**Consumers
Power
Company**

December 1, 1980

DOCKET 50-255 - LICENSE DPR-20 -
PALISADES PLANT - AUXILIARY
FEEDWATER MODIFICATIONS

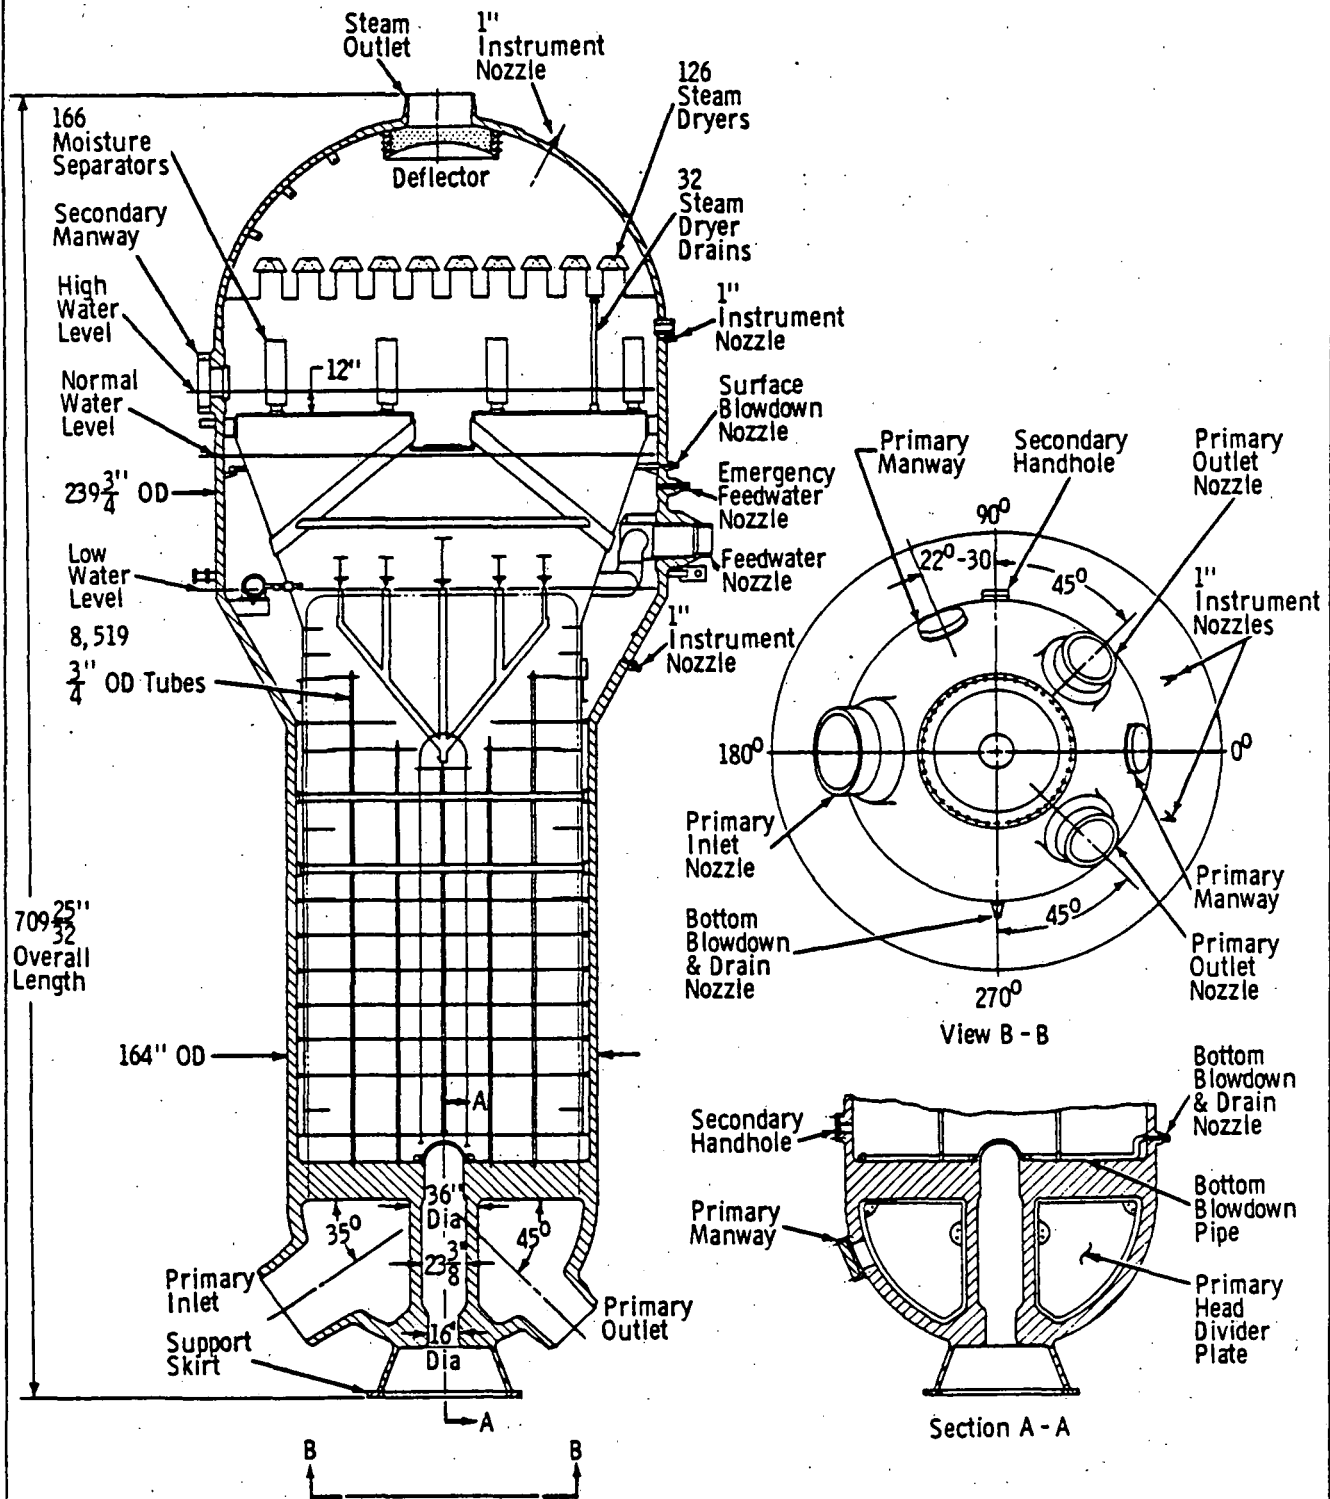
The modification consists of disconnecting the auxiliary feedwater lines from the main feedwater lines, routing the lines through existing spare containment penetrations to existing auxiliary feedwater nozzles (labeled Emergency Feedwater Nozzle on Figure 1) on the steam generators, and providing a separate auxiliary feedwater sparger inside each steam generator. The piping arrangement is shown in Figure 2 and the nozzle and sparger assembly are shown in Figure 3.

AUXILIARY FEEDWATER PIPING
CONSUMERS POWER CO.
PALISADES SITE
FIG. 3

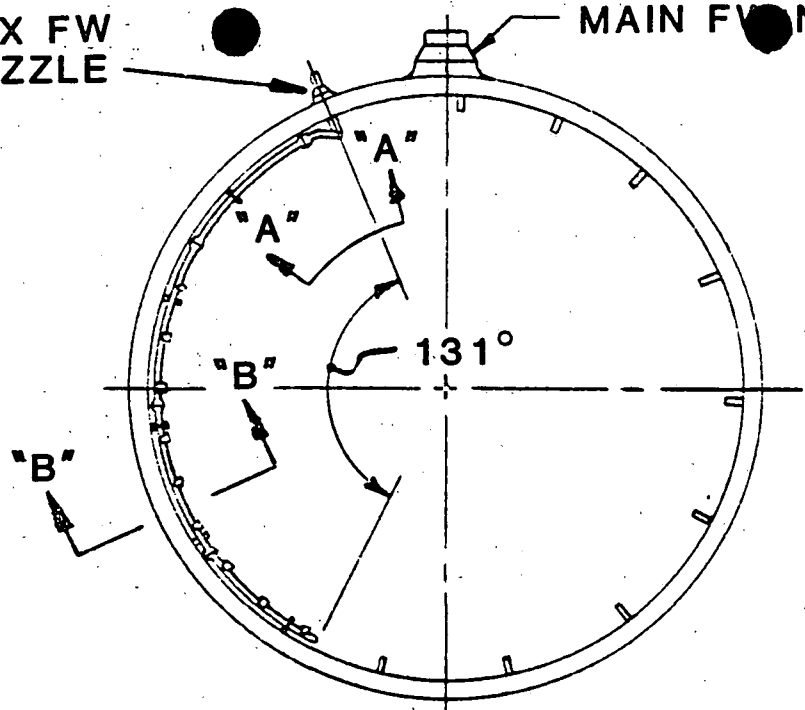
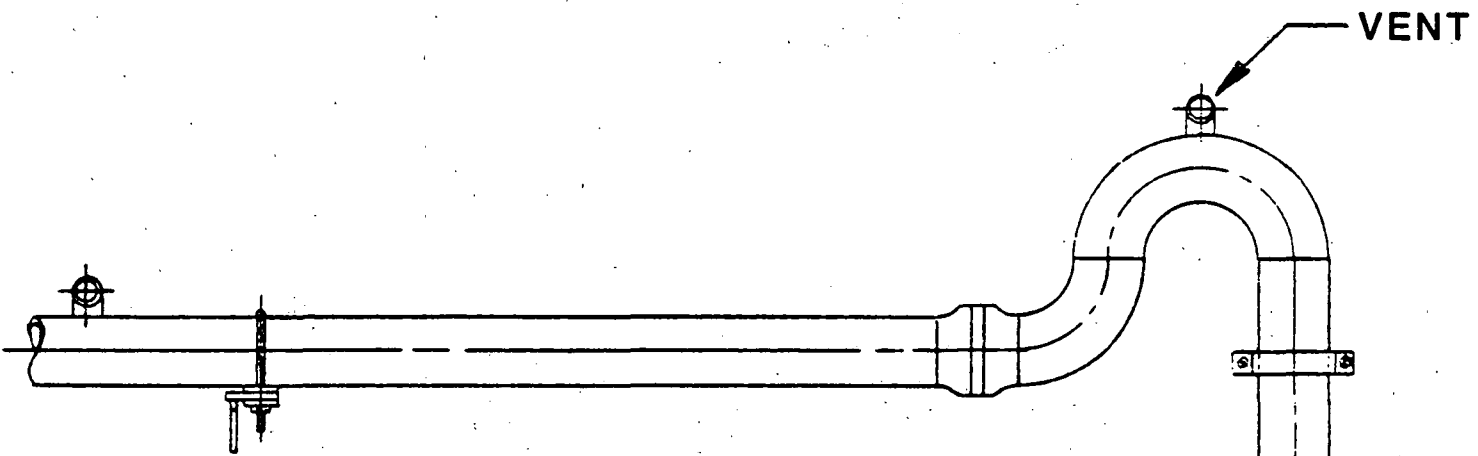
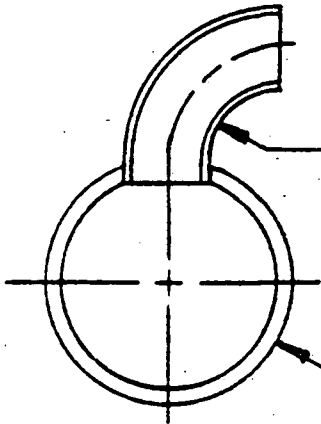
The existing auxiliary feedwater nozzle forgings will be equipped with thermal liners to allow cold feed injections, and the acceptable number of such cycles will be analytically determined. The piping reaction at the nozzles will also be evaluated for acceptability. The new spargers for auxiliary feedwater will be designed in accordance with the current design practice for CE steam generators. A number of design features will be incorporated specifically to reduce the susceptibility to water hammer. The piping in the vicinity of the steam generators will be sloped down away from the generators (see Figure 2). The sparger will be arranged with a top discharge and provided with a water trap as shown on Figure 3 to prevent the sparger from draining when the steam generator water level drops below the sparger. A vent will be provided at the highest point of the sparger water trap as shown.
